**CERTIFICATION REPORT FOR
AREA 6 GENERAL AREA EAST**

**FERNALD CLOSURE PROJECT
FERNALD, OHIO**

**20600-RP-0007
REVISION 0
PCN 1**

**VARIANCE/FIELD CHANGE NOTICES FOR THE CDL AND
CERTIFICATION PSP FOR AREA 6 GENERAL AREA EAST**

FIGURE 1.

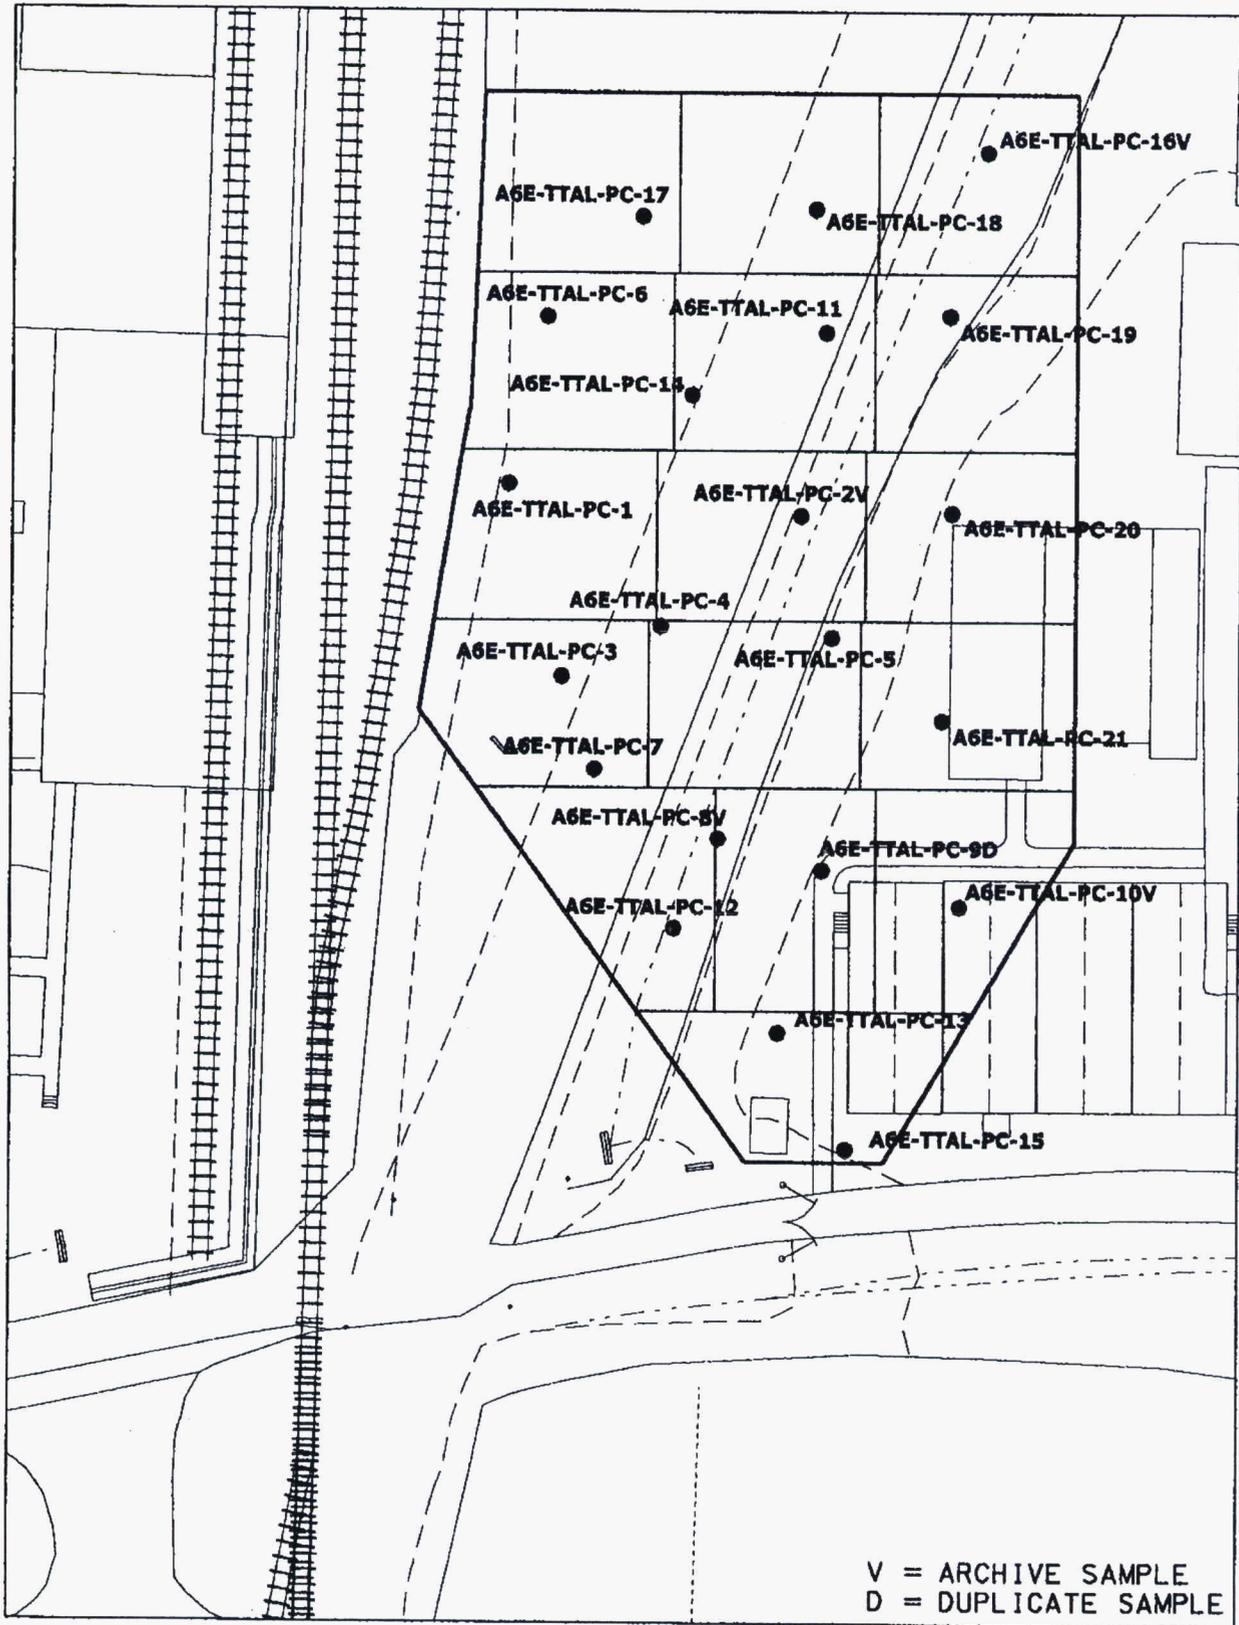
The V/FCN documents the collection of physical soil samples for the area in the southwest corner of Area 6I for precertification. This area is needed to build a pad with access to the rail line to load out TTA material. See Figure 1. Coordinate with the Construction Lead (Tim Hastings 476-3590).

Analysis will be conducted to Analytical Support Level (ASL) D or E, where all requirements for ASL E are the same as ASL D except the minimum detection level for the selected analytical method must be at least 10 percent of the FRL. A full analytical data package is to be provided and the data is to be validated to Validation Support Level (VSL) D. Any archive samples indicated on Figure 1 or Attachment 2 will not be collected at this time.

FIGURE 1.

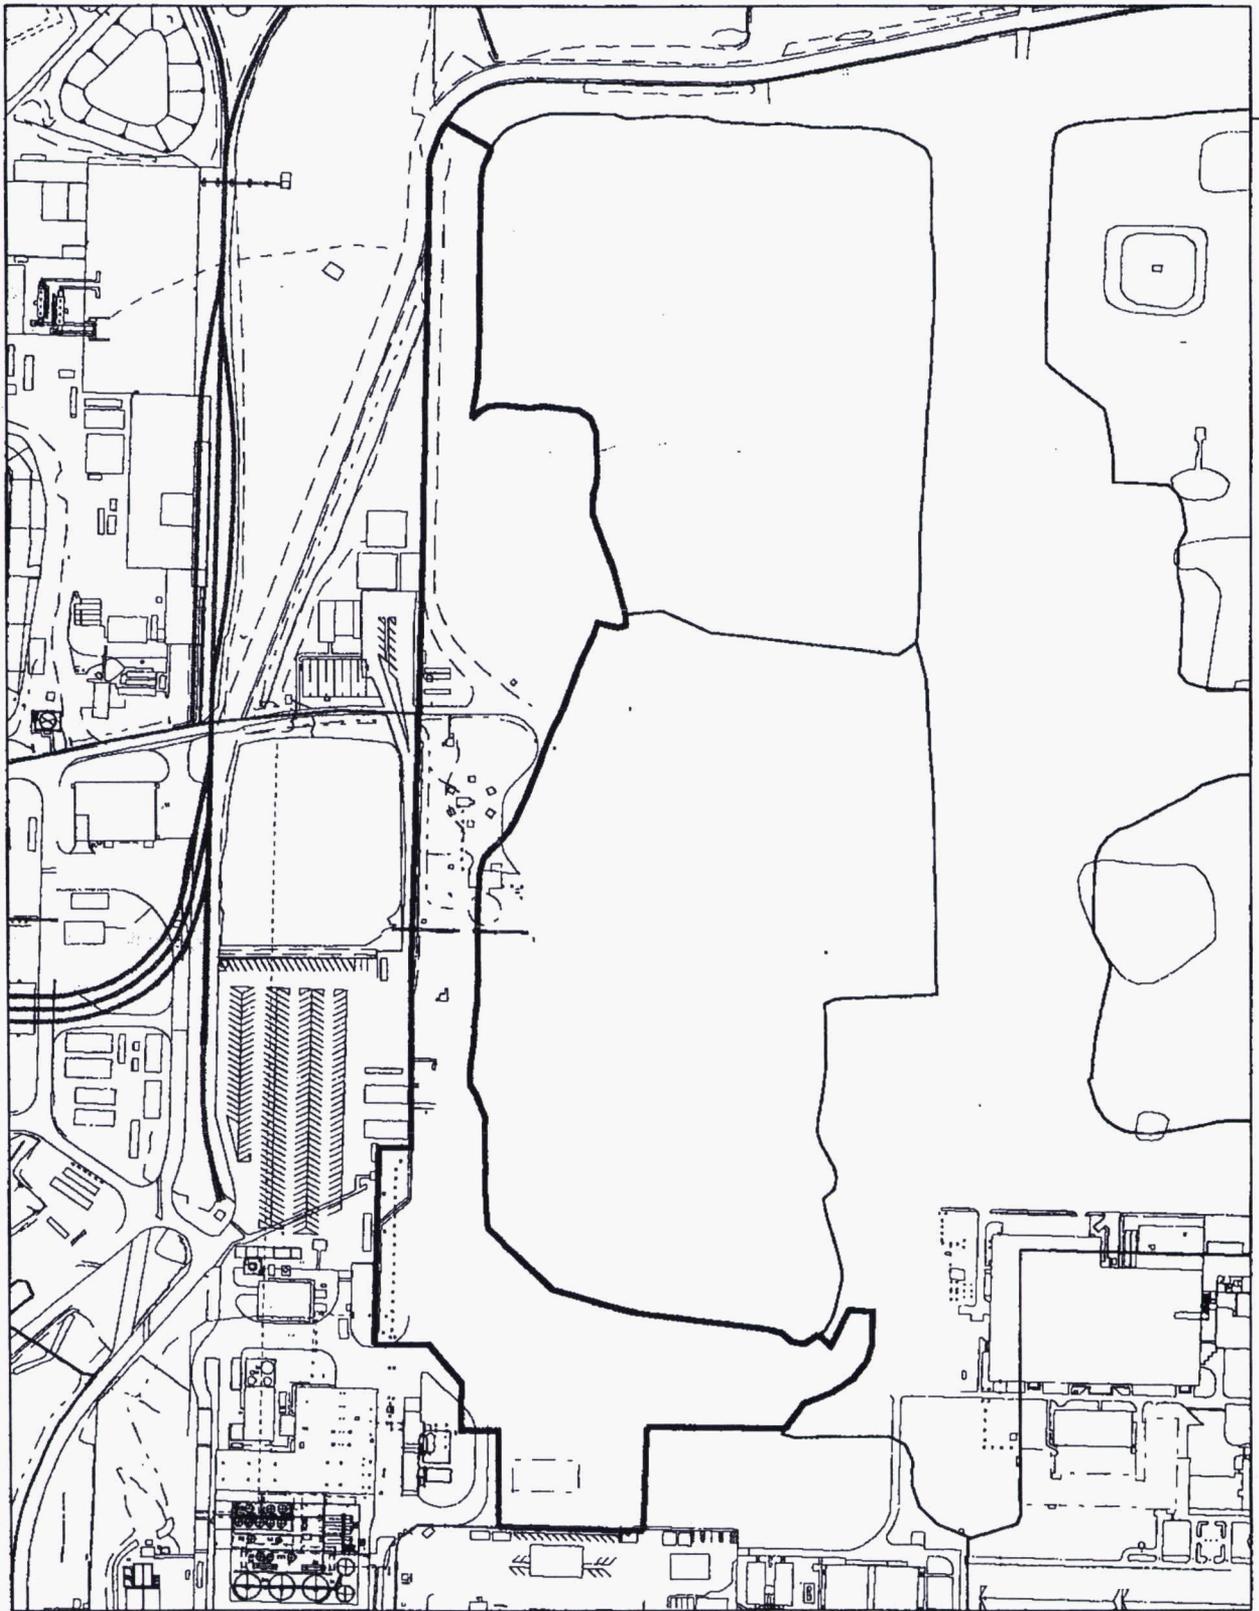
This Variance/Field Change Notice (V/FCN) documents the collection of physical soil samples for precertification of the soil beneath the bedding of excavated utilities located in the western sections of Areas 3B and 4B (Figure 1). Construction will be excavating known utilities; however, the possibility exists that unknown utilities will be uncovered during excavation. All sampling locations will be field located approximately every fifty feet along the bottom of the excavation. All samples will be collected from the bottom of the excavation from the bucket of an excavator (if necessary) after the piping and bedding material has been removed. The goal will be to collect samples from the top six inches of soil from the bottom of the excavation. The estimated number of samples is 30.
